**STAFF REPORT: JULY 9, 2025 MEETING**  
**APPLICATION NUMBER: HDC2025-00404**  
**ADDRESS: 1760 WABASH**

**HISTORIC DISTRICT: CORKTOWN**  
**APPLICANT: TIM FLINTOFF, 4545 ARCHITECTURE**  
**PROPERTY OWNER: DETROIT DEVELOPING PROPERTIES LLC**  
**DATE OF PROVISIONALLY COMPLETE APPLICATION: JUNE 16, 2025**  
**DATE OF STAFF SITE VISIT: JULY 8, 2025**

**SCOPE: REPLACE SIDING, INSTALL ALUMINUM-CLAD WOOD WINDOWS (WORK COMPLETED WITHOUT APPROVAL)**

*Applicant drawing, facade.*

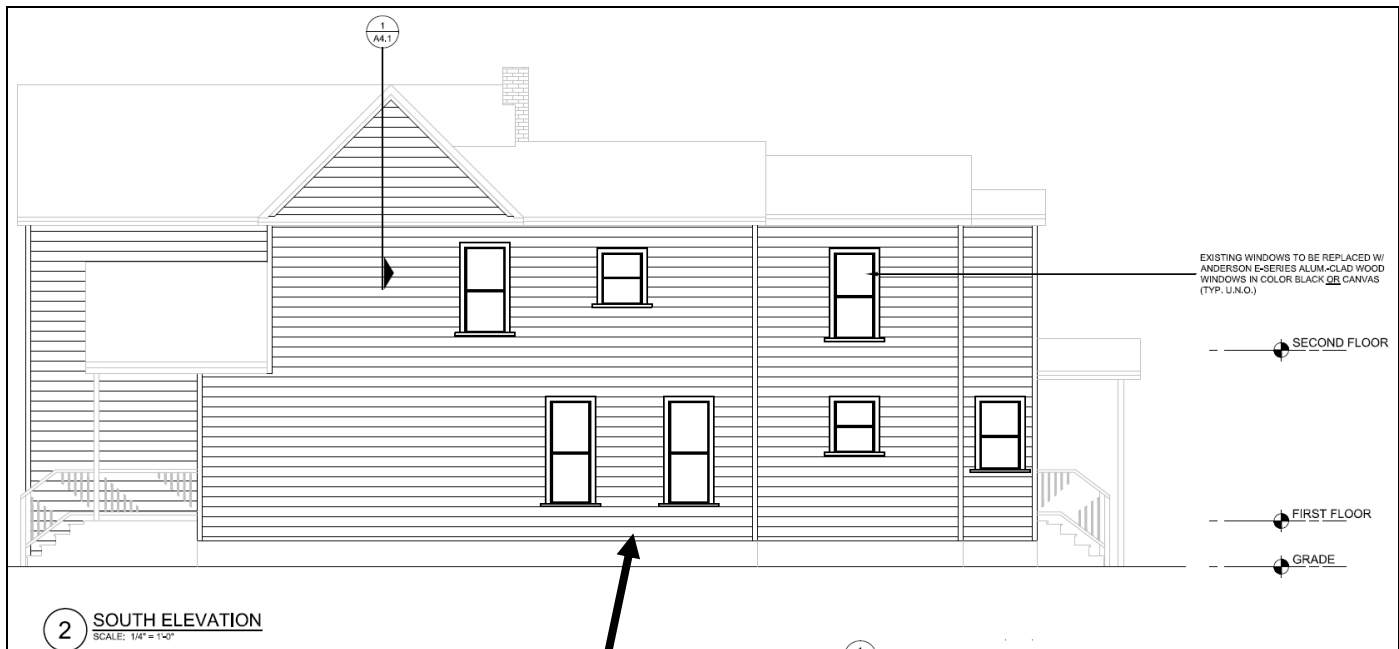
- The applicant's drawings depict the dimensional changes proposed for the existing window openings on each wall of the dwelling, as well as the re-established façade gable window opening. Compatably dimensioned/profiled wood window casings and mullions are also shown detailed on the drawings.

- The photos below depict conditions prior to the recently completed work. Comparing the photos of the two dominant and fully visible walls of the dwelling with the current drawings show the alterations proposed within this application will reclaim the dimensions and proportionality of the historic window openings and window casings.

- Specifications for glass and screens will be submitted to staff for review, confirming transparency of the window openings will be retained.
- The final window order will be submitted to staff for review.
- The drawings will be updated to list the previously approved paint colors for the wood siding and window trim/casings, as well as the dimensions and installation specifications for the 7.25" western red cedar siding.
